[Docket No. FAA-2006-25773; Directorate Identifier 2006-SW-16-AD; Amendment 39-14758; AD 2006-19-01]

Airworthiness Directives; Eurocopter Model AS350B, B1, B2, B3, BA, D, and AS355E Helicopters

ACTION: Final rule; request for comments.

Figure 1

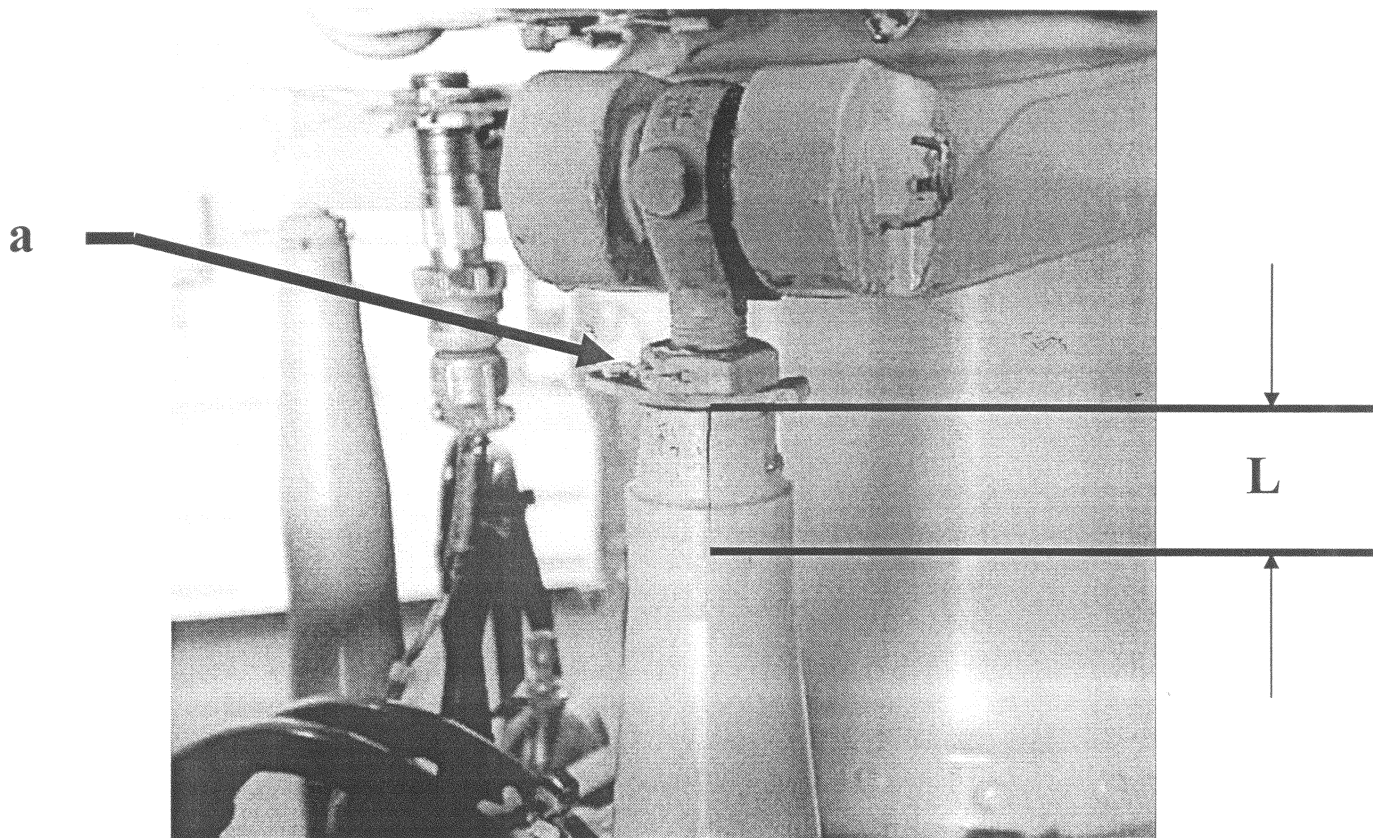
(3) Loosen attachment nut “a” shown in Figure 1 of this AD and lift the positioning lock washer under the attachment nut so the edge below the lock washer at the top of the tapered housing is visible around the entire periphery.

(4) Visually inspect each MSC tapered housing for a crack using a 10-power or higher magnifying glass paying particular attention to area “L” and to the edge of the tapered housing located under the lock washer under attachment nut “a” as depicted in Figure 1 of this AD.

(1) Adjust the tightening torque on the attachment nut that secures the upper ball end of the MSC to between 177–199 in-lbs (2–2.25 decanewton meters (daN·m)).

(c) If you find any crack (oblique, horizontal, or vertical), before further flight, replace the MSC with an airworthy MSC and adjust the tightening torque of the attachment nut to between 177–199 in-lb (2–2.25 daN·m)).
